Other Observed Issues

Plans versus Observed Construction

Rear Elevation Load Bearing Wall **Family Room**

2080 Other Observed Issues

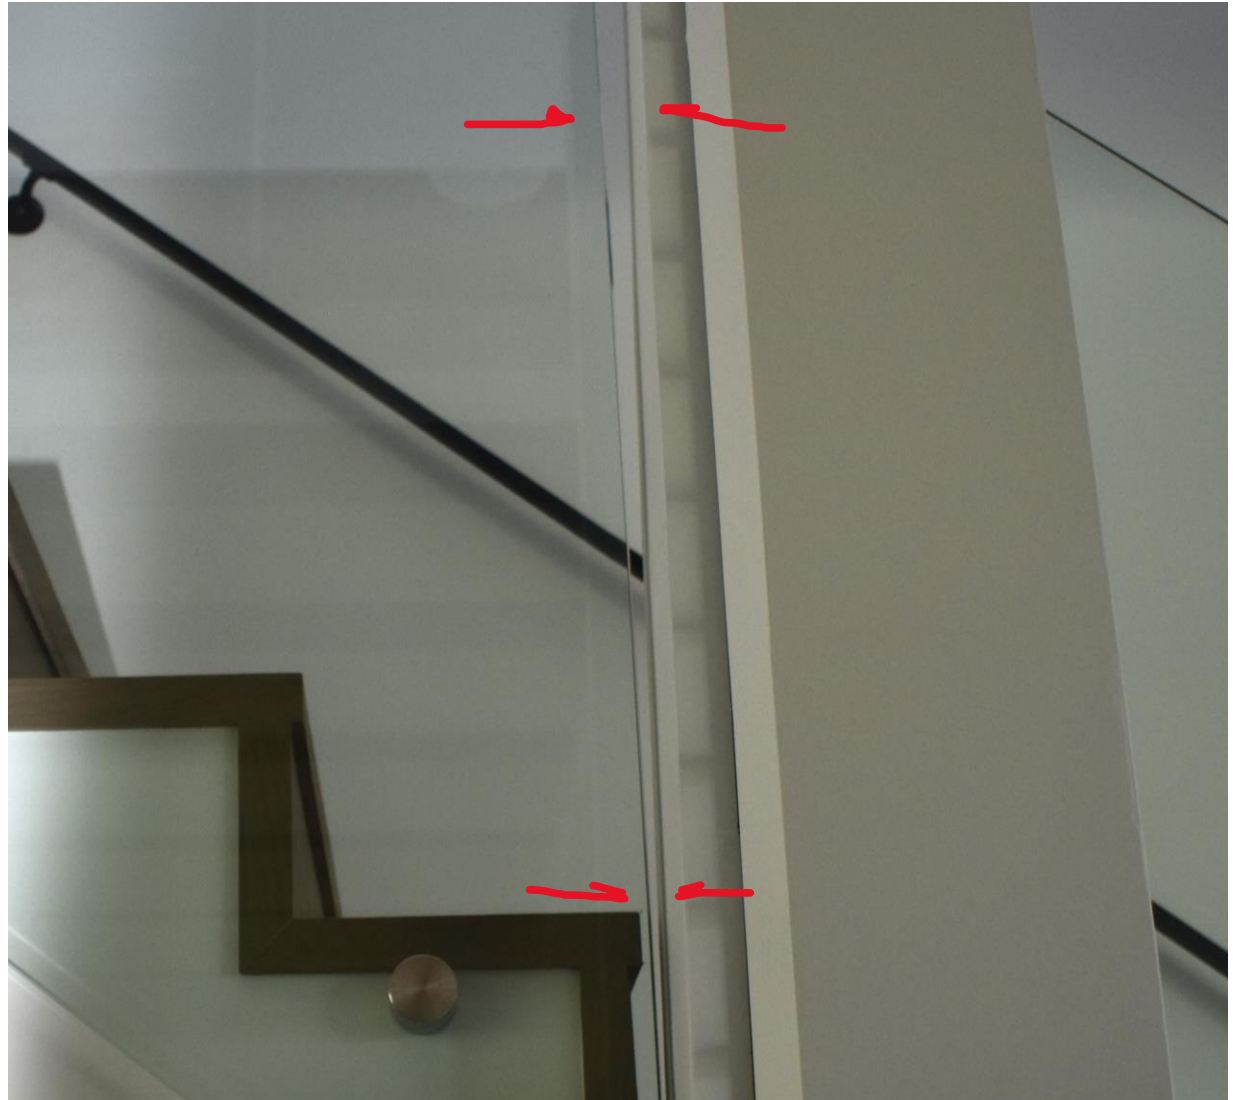
Original plans call for a metal handrail, cables and posts.

Glass handrail installed. Installation fit and finish less than desirable.

Note inconsistent gap at intersection with wall.

This was installed with

No Engineering

No Permit changes

No Inspections

2046 Other Observed Issues

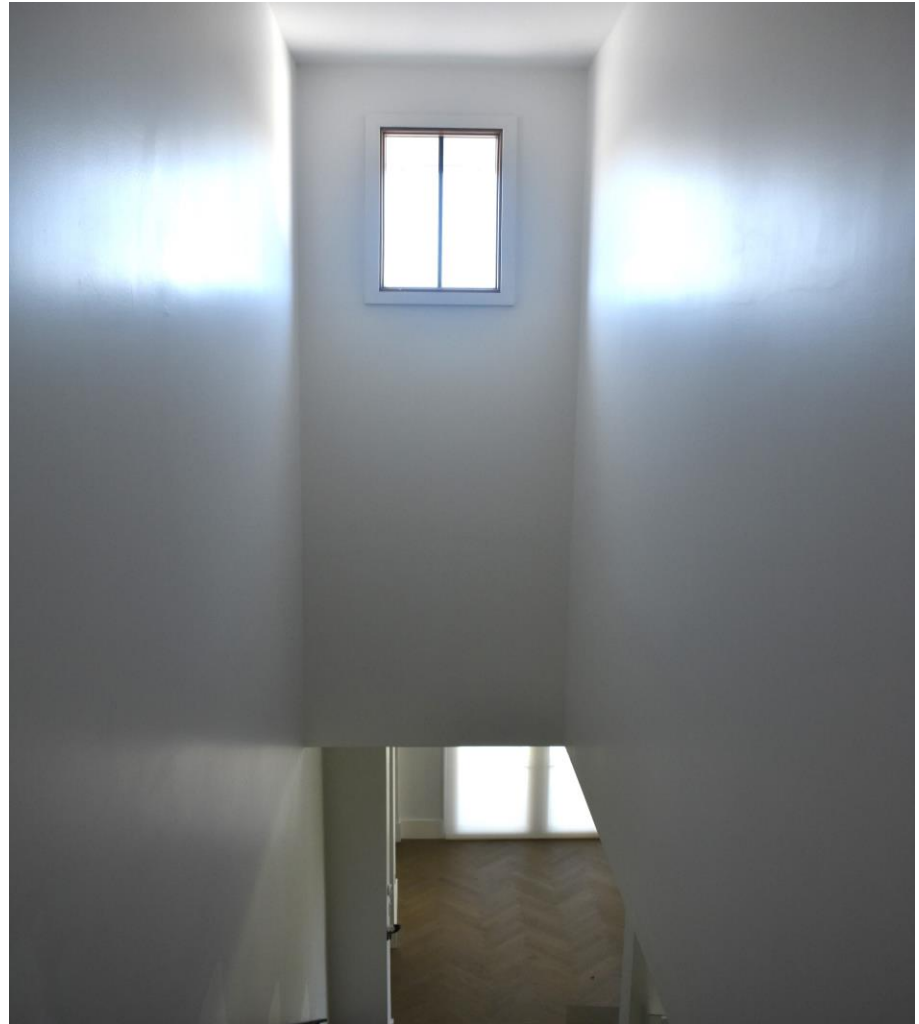
**Third tankless hot
water heater installed under the
exterior stairway on garage.**

**Not shown on original or as-built
drawings.**

2070 Other Issues

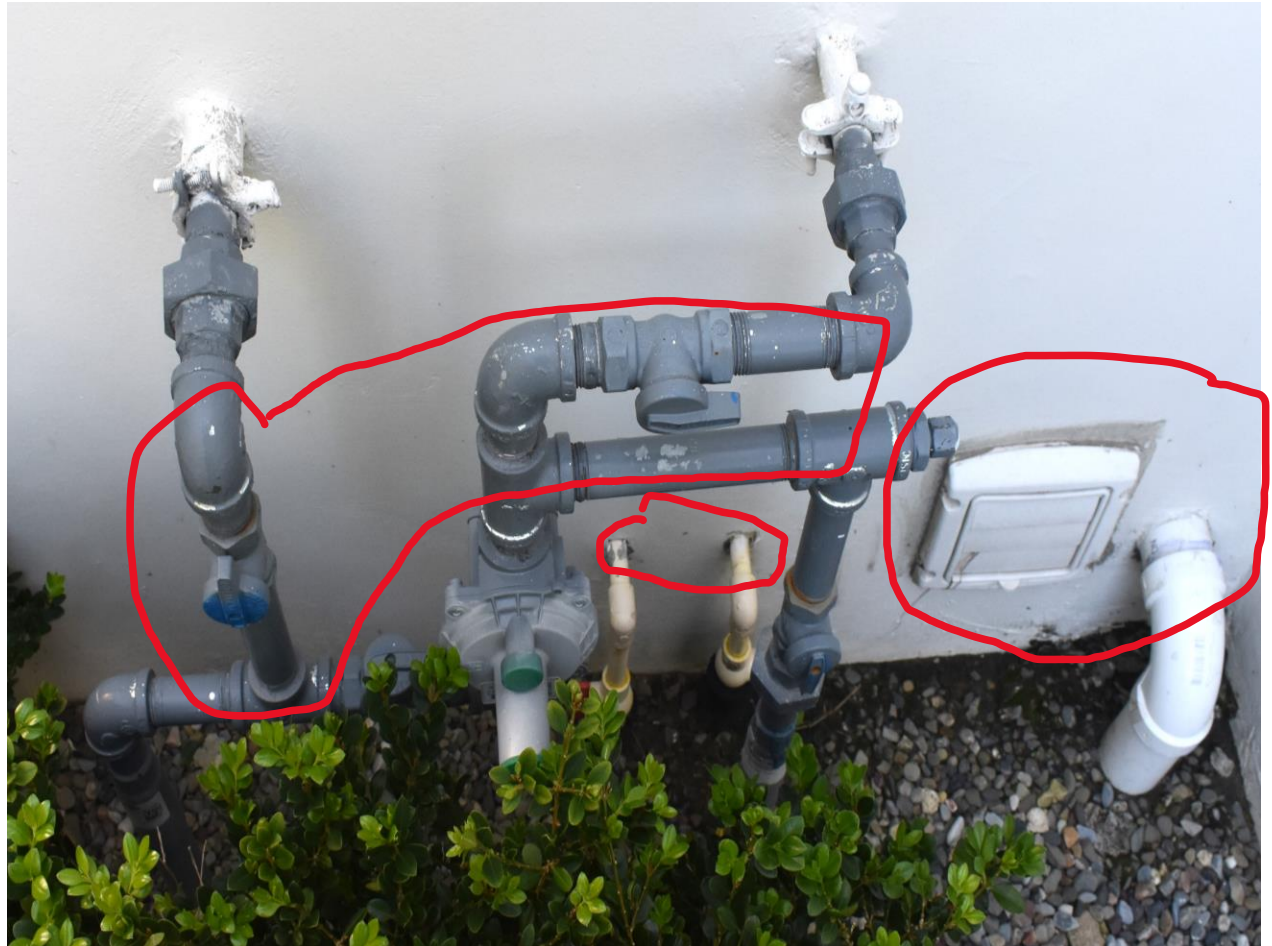
Front wall not in the original or as-built plans.

Permit NOT acquired but no way to determine compliance to Code.

Gas lights on wall do not work.

2078 Plans versus Observed Construction

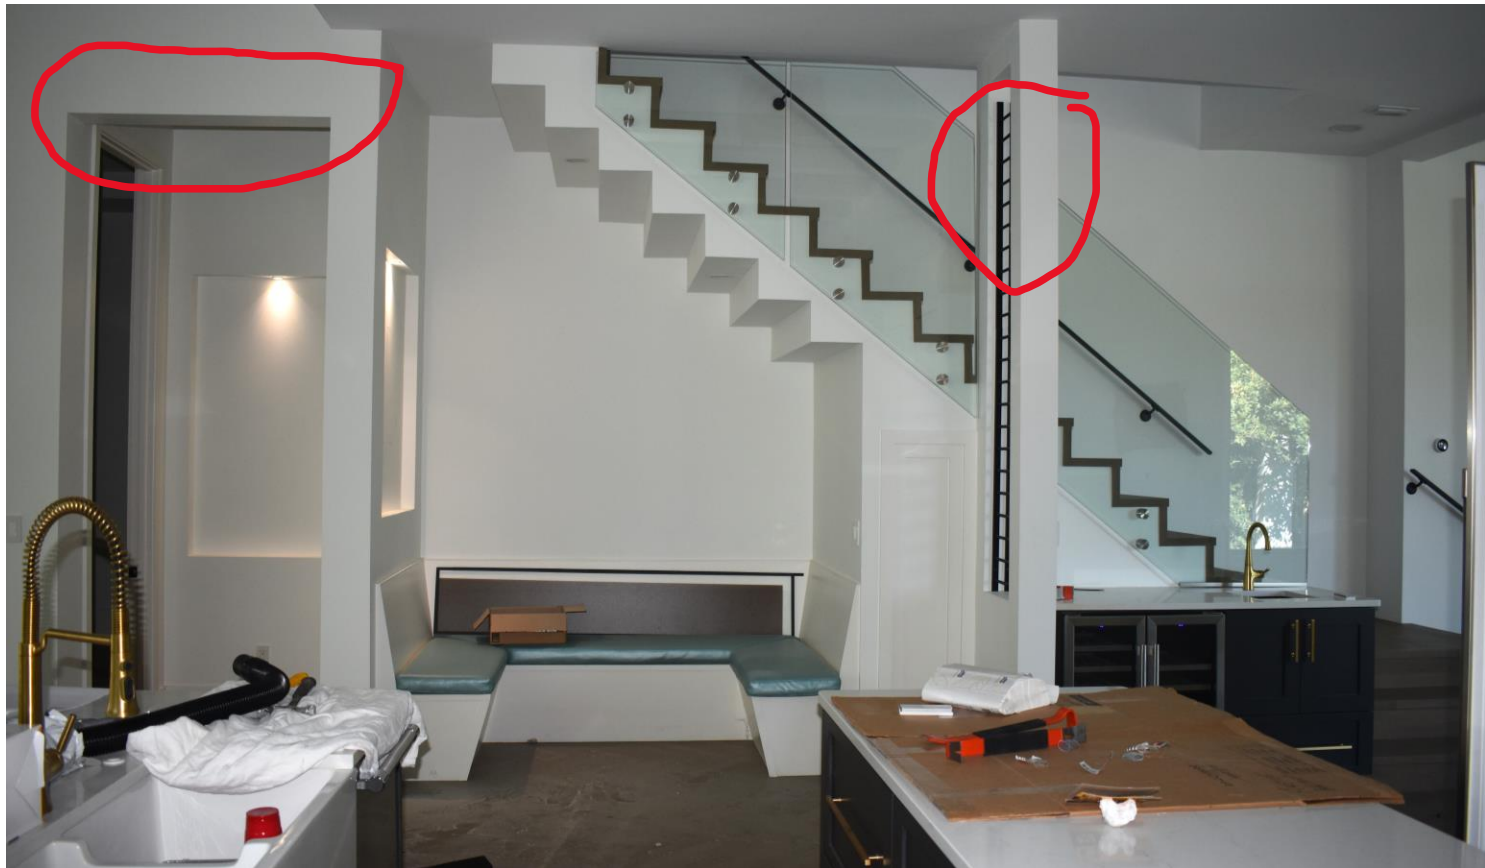
The wall pictured from left to right is load bearing and shall contain areas where multiple King studs are used, The bedroom egress wall, the short-wet bar wall are also load bearing. Three pre-engineered laminated columns are also designated for use. At least two laminated posts designed for 3100 SP are missing.

City of Winter Park Building Inspectors failed to enforce Drawings/Engineering

2078 Plans versus Observed Construction

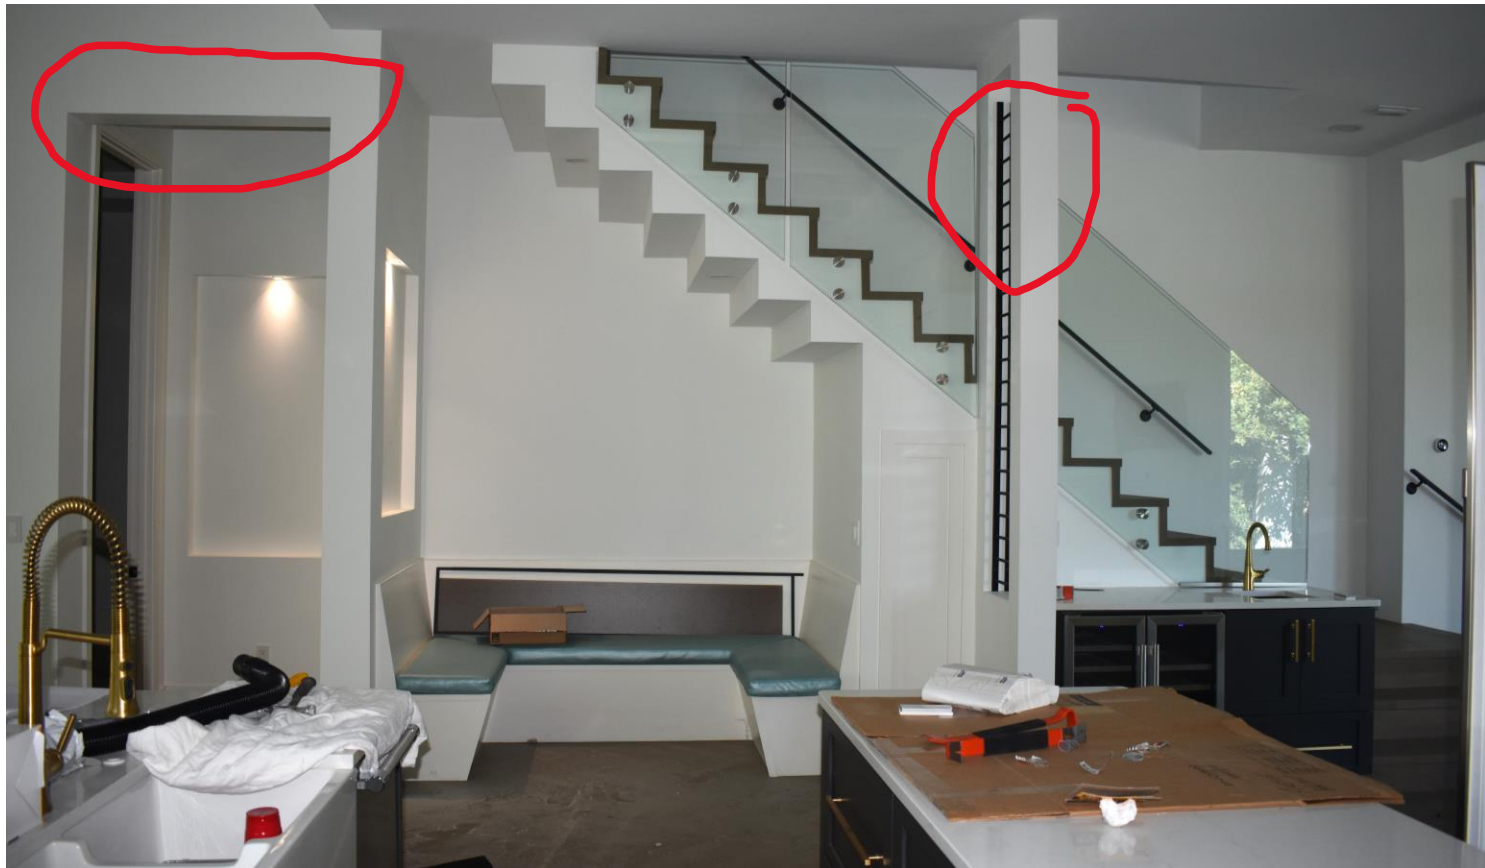
The wall pictured from left to right is load bearing and shall contain areas where multiple King studs are used, The bedroom egress wall, the short-wet bar wall are also load bearing. Three pre-engineered laminated columns are also designated for use. At least two laminated posts designed for 3100 SP are missing.

City of Winter Park Building Inspectors failed to enforce Drawings/Engineering

0310A Rear Elevation Wall Exposed

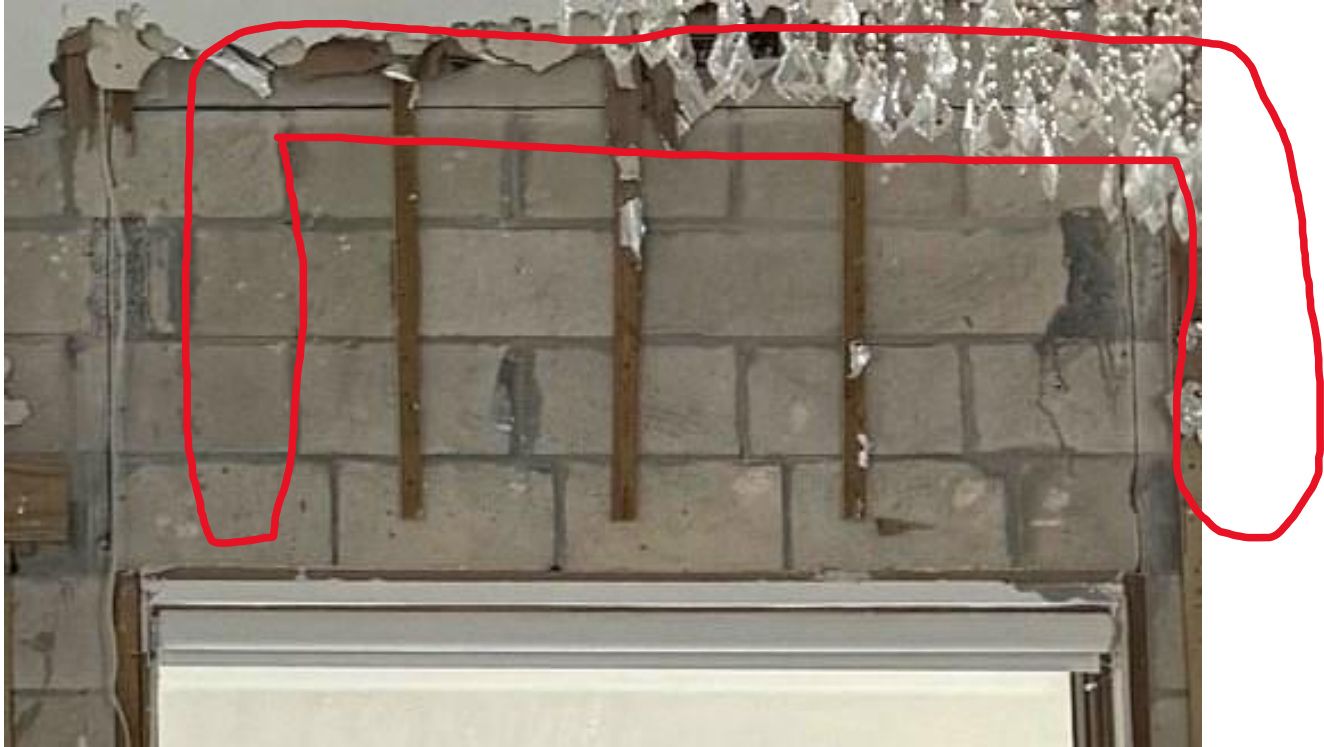
To install the oversized window the contractor saw cut the existing masonry wall on the left and right sides and extended the cut four courses above the window and horizontally.

Then removed the wall section by mechanical means.

With no details or approval or calculations to address this significant structural change the load bearing capacity of this wall has been severely compromised and poses a life safety issue.
